RHODE ISLAND DEPARTMENT OF TRANSPORTATION

Bridge Group 54A -Kingston Rd Bridge

NOTICE TO PROSPECTIVE BIDDERS

ADDENDUM NO. 2 Prospective bidders and all concerned are hereby notified of the following changes in the Plans, Specifications, Proposal and Distribution of Quantities for this contract. These changes shall be incorporated in the Plans, Specifications, Proposal and Distribution of Quantities, and shall become an integral part of the Contract Documents.

**SOUTH ABUTMENT
PLAN AND ELEVATION**

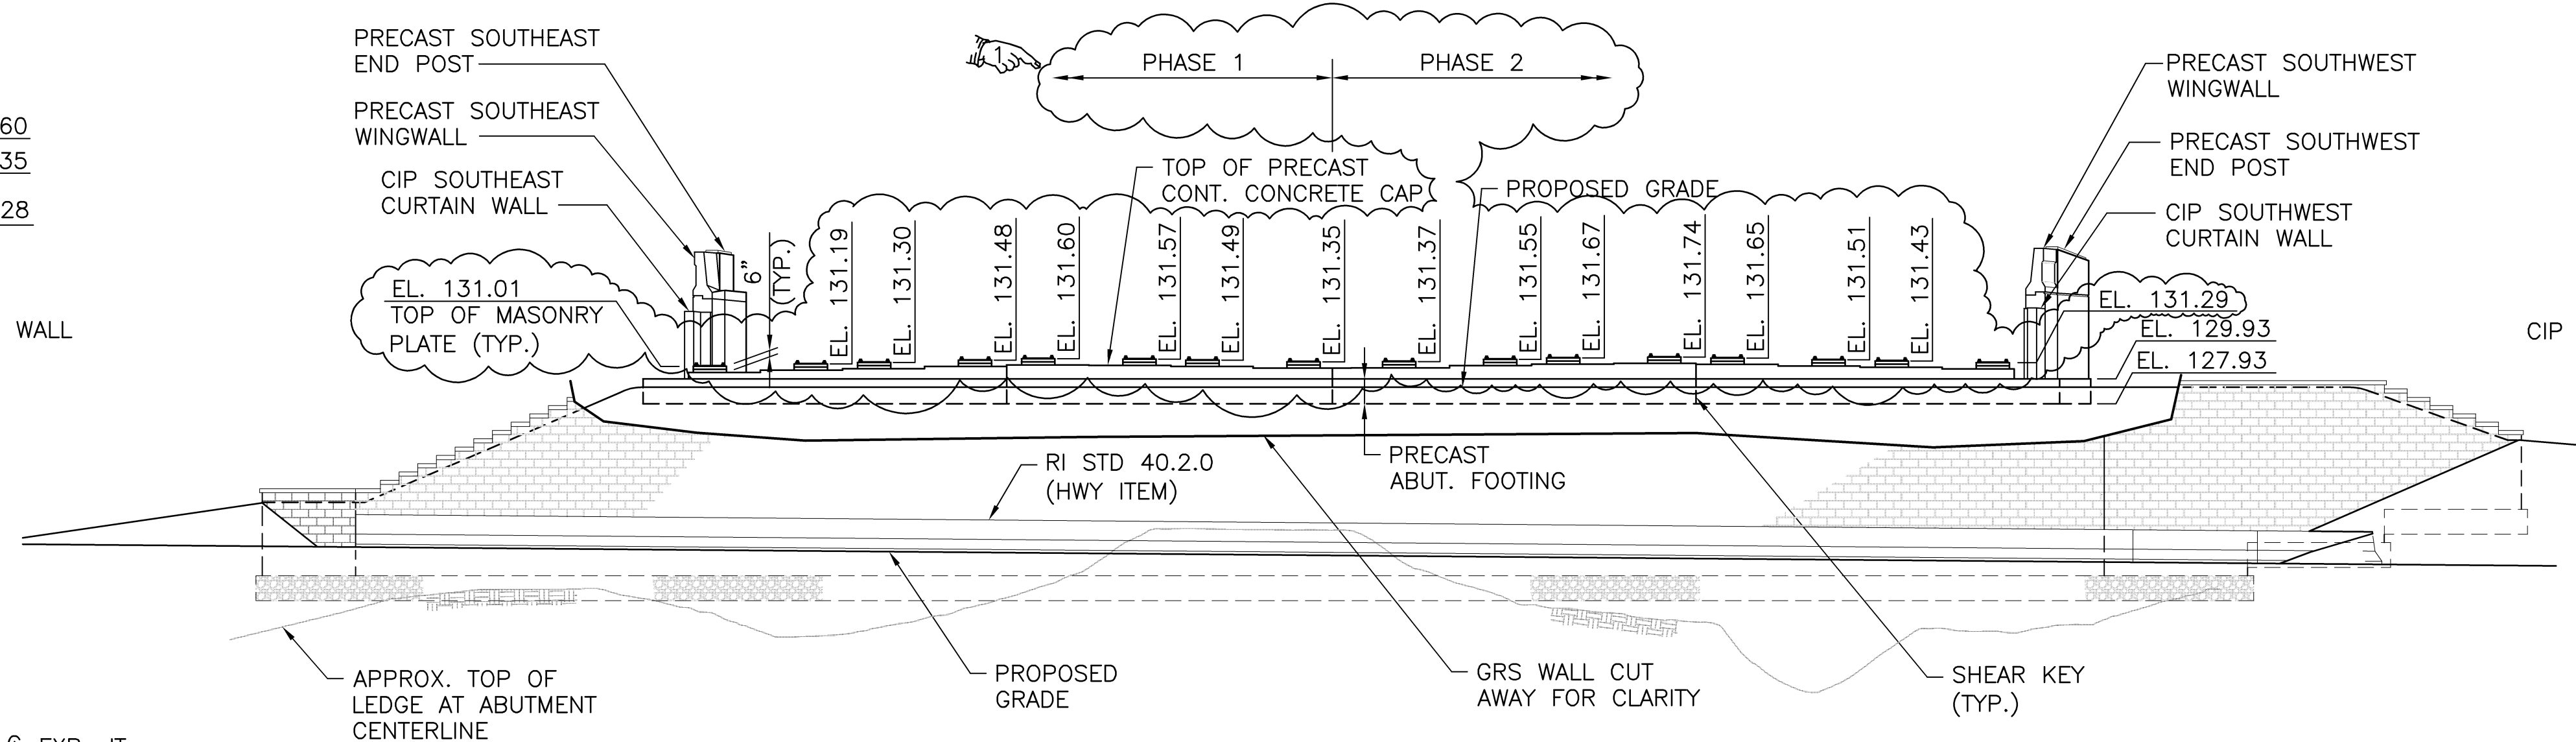
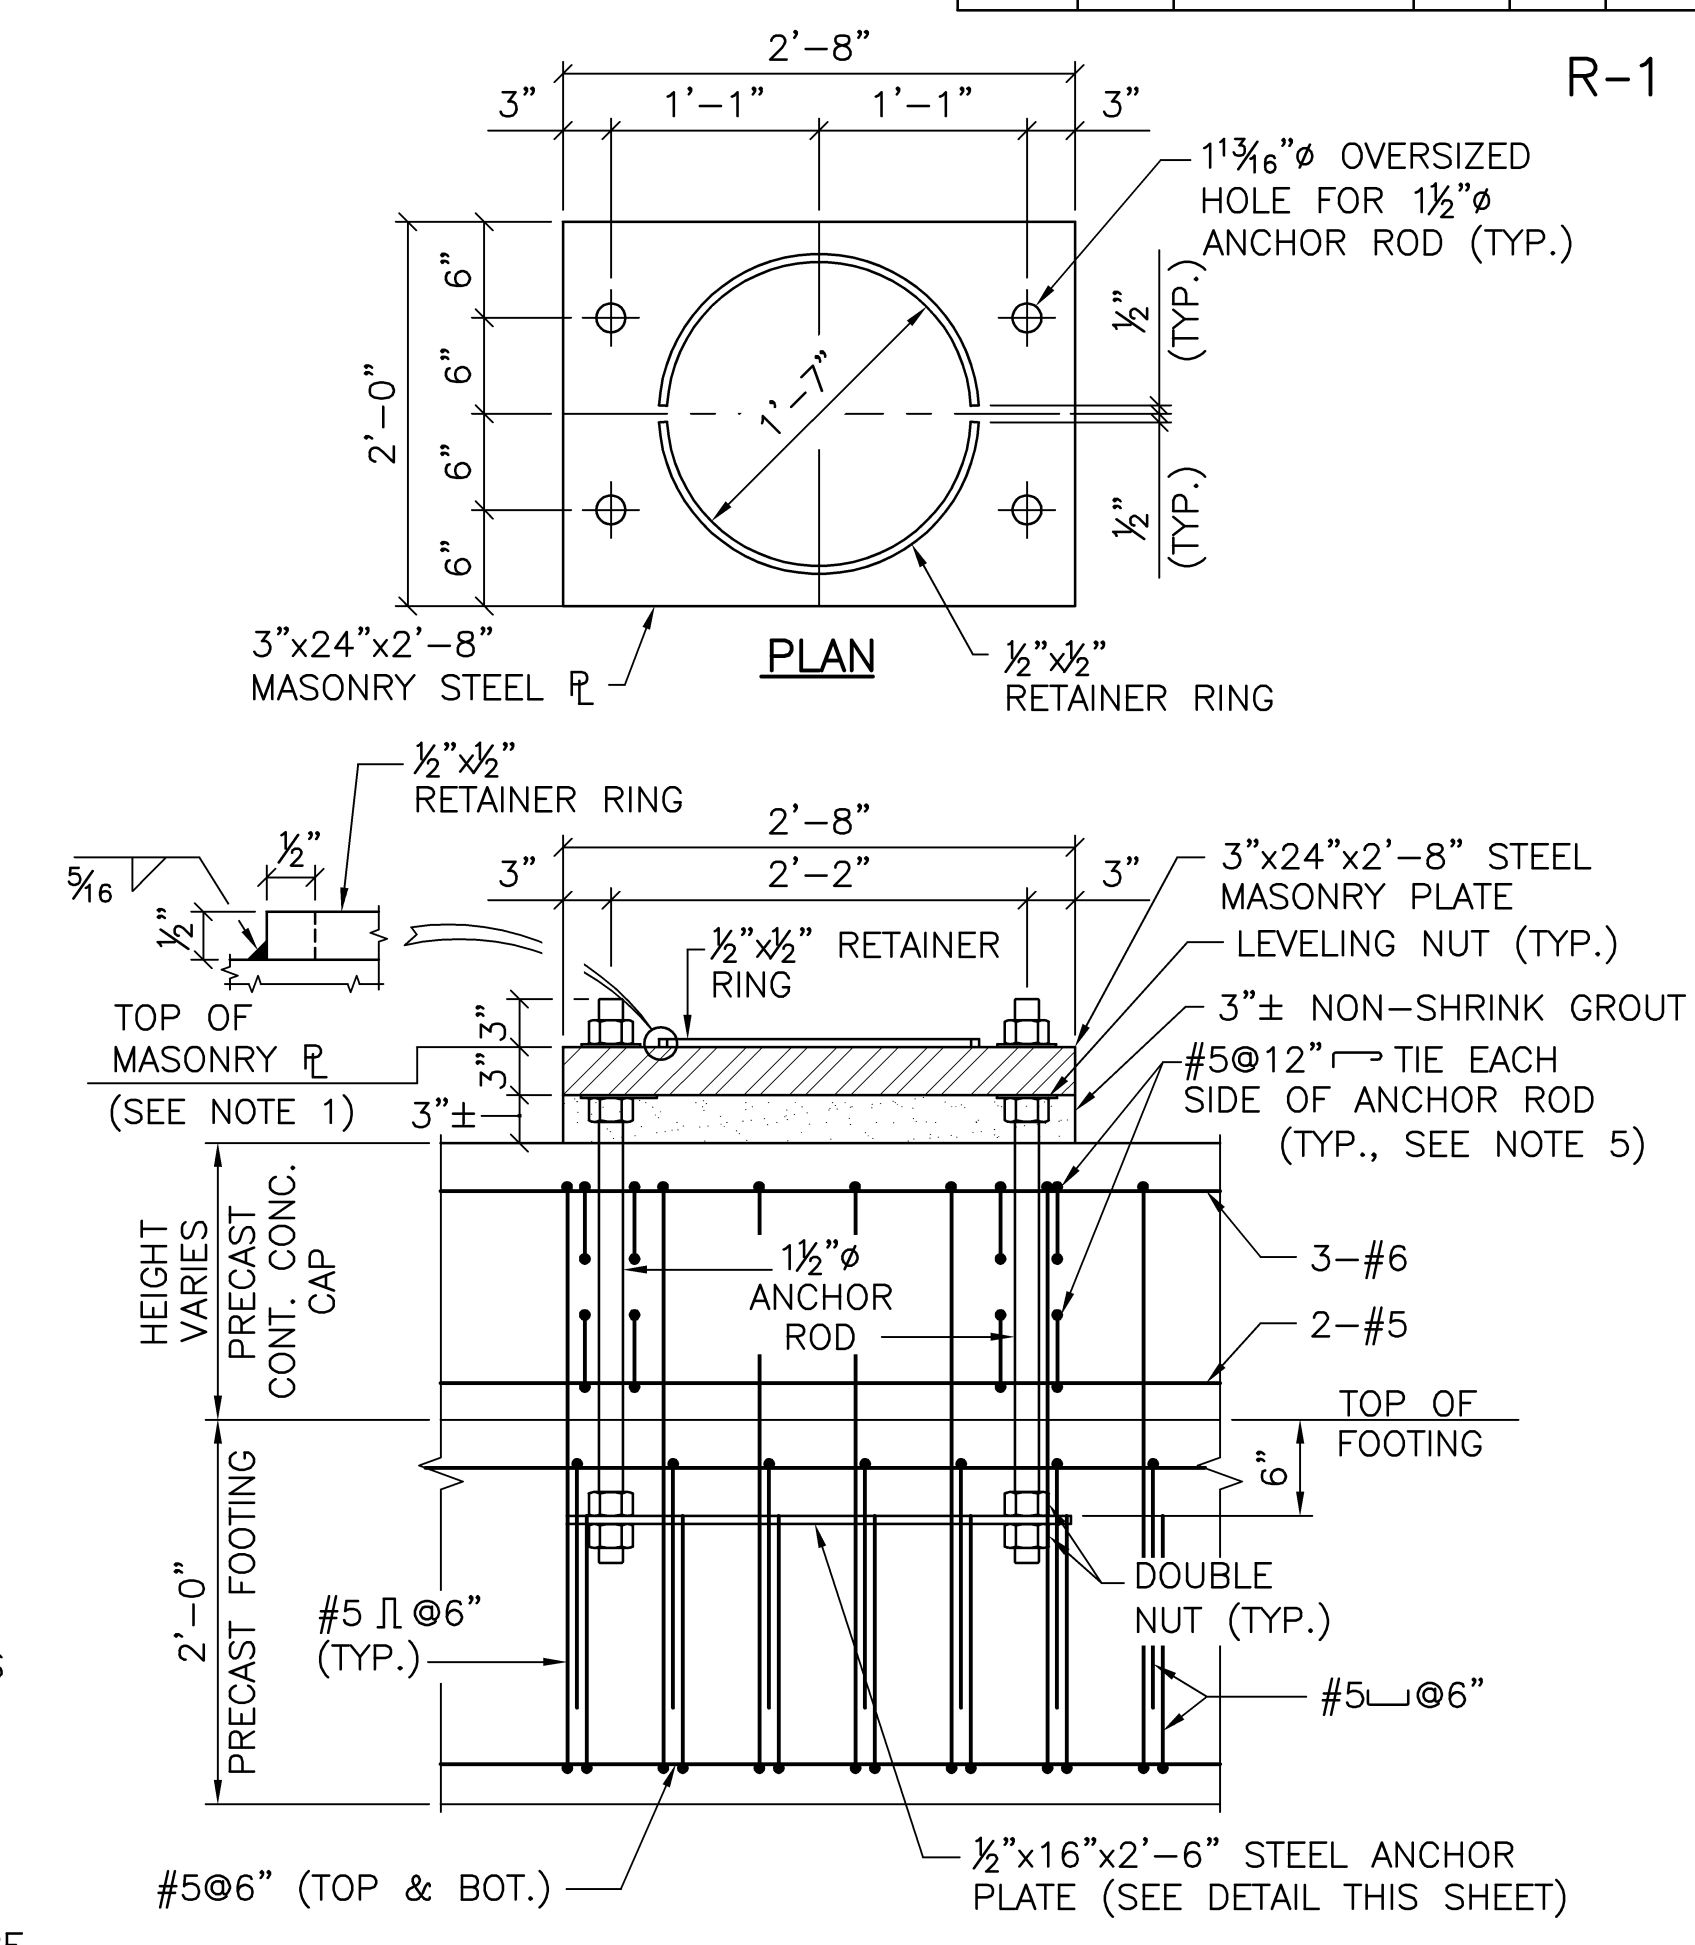
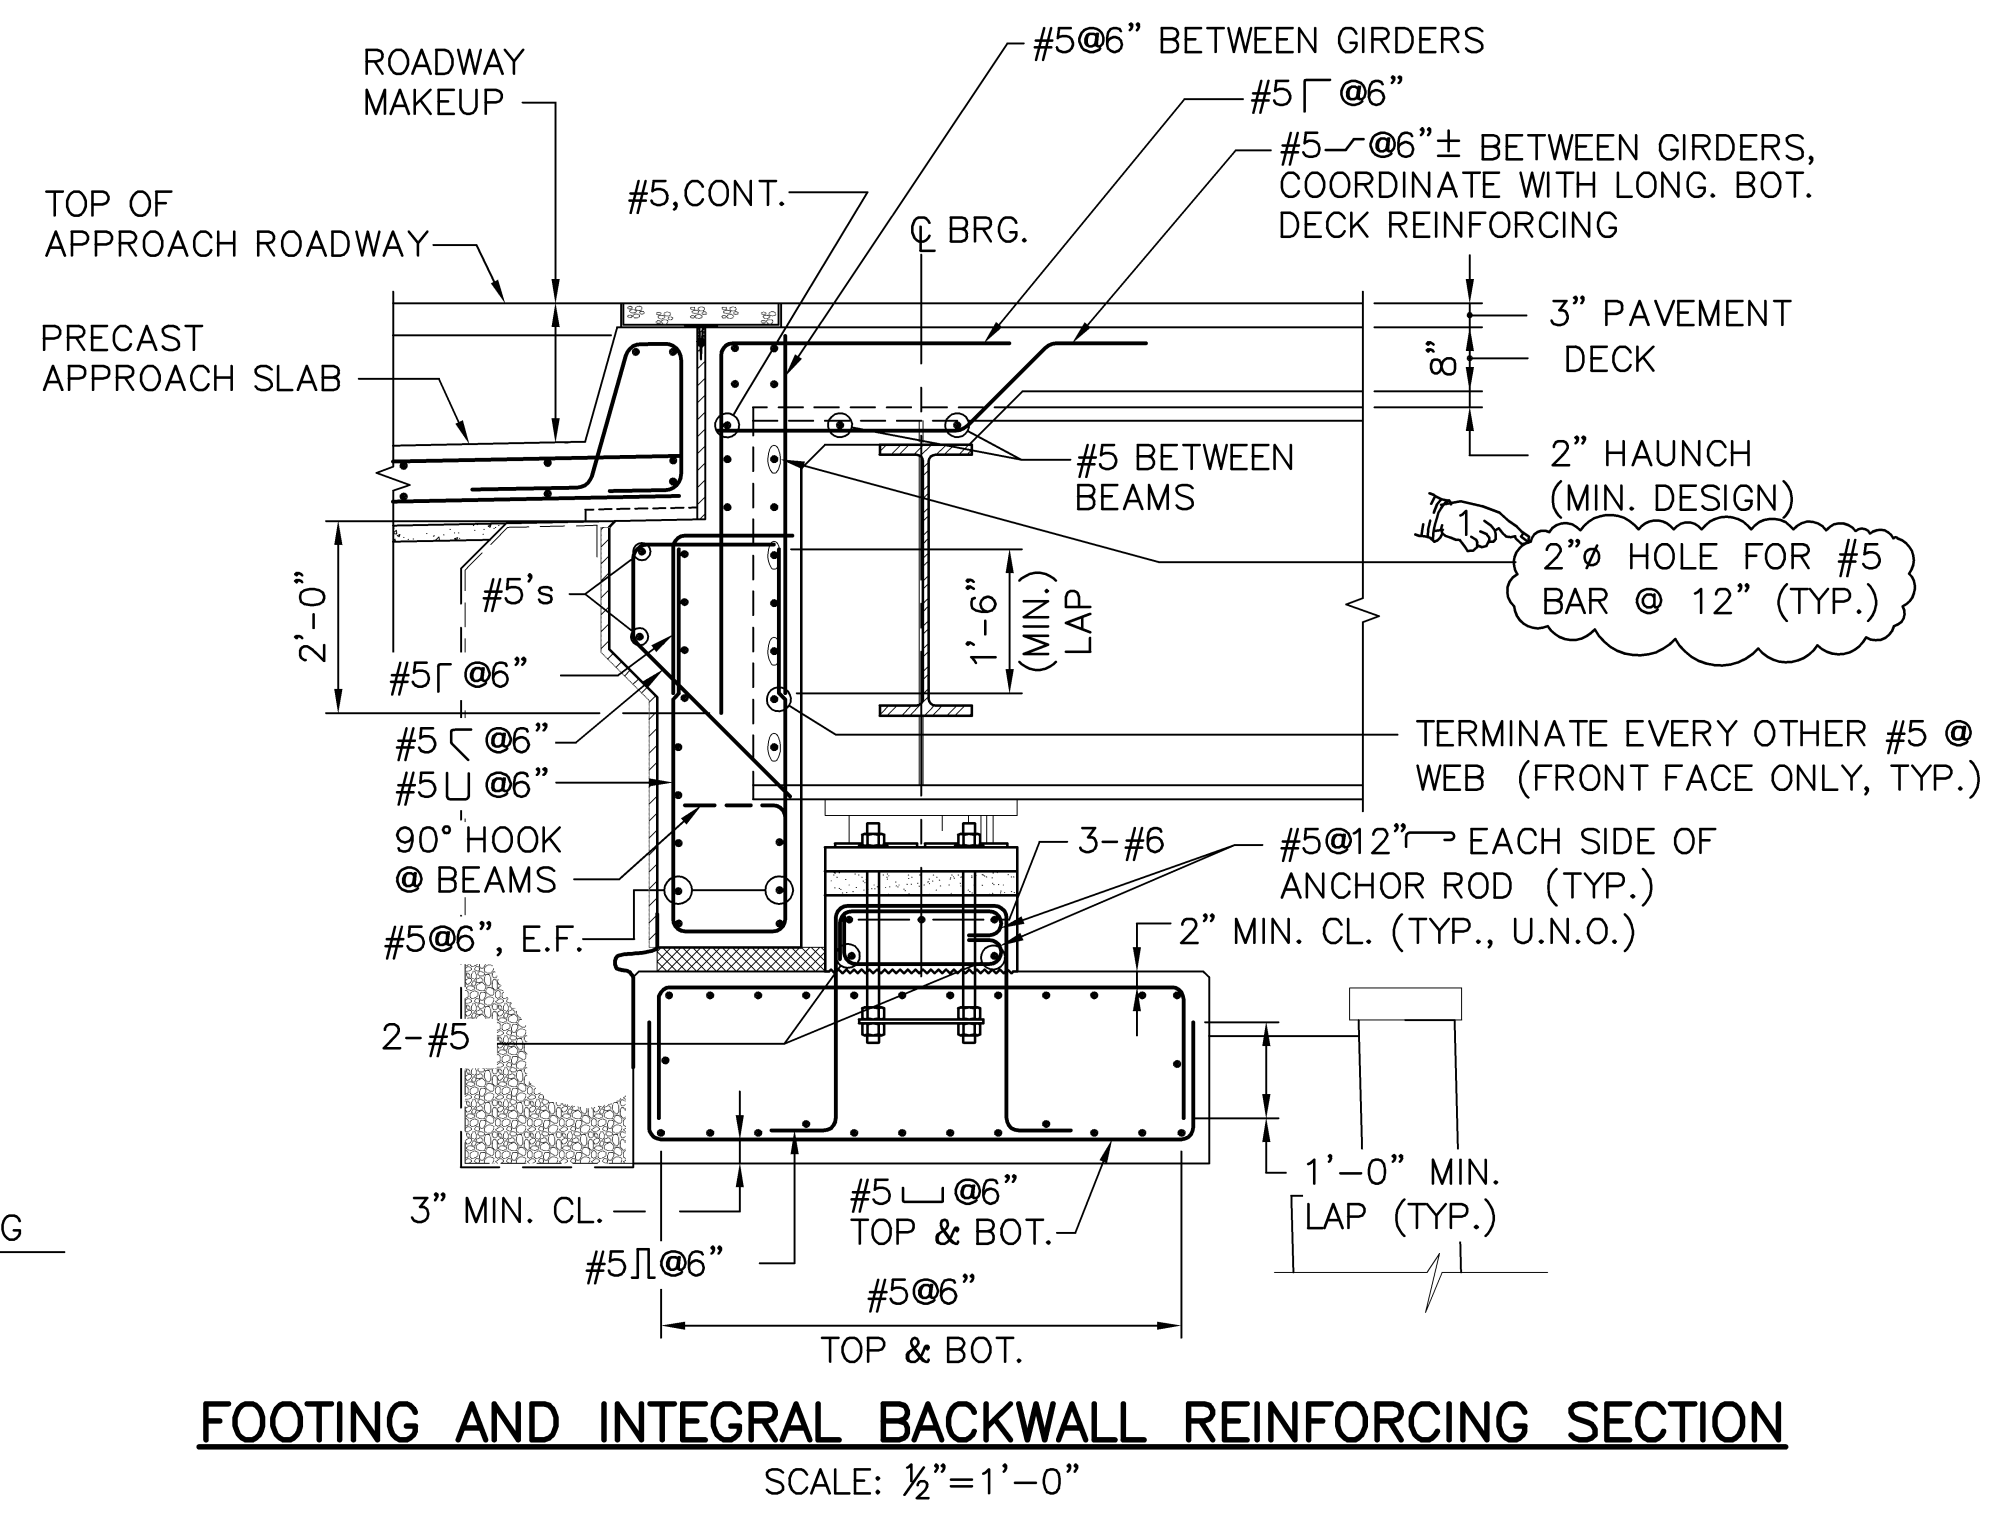
5. Volume 2 Plan Sheet No. 19 - South Abutment Plan & Elevation
Remove Volume 2 Sheet No. 19 in its entirety and replace it with revised Sheet No. 19 (R-1) attached to this Addendum No. 2. South Abutment Plan & Elevation sheet has been revised.

Please confirm-----Due to the phase line SOE , the GRS/IBS Abutments (both north and south) , once they are completed , will not be one continuous abutment , but will have a non connecting joint at the phase line.

Due to the phase line SOE, the GRS/IBS Abutments will have a non-connecting joint along the phase line. Notes and/or details will be added to the Contract Drawings by Addendum to clarify.
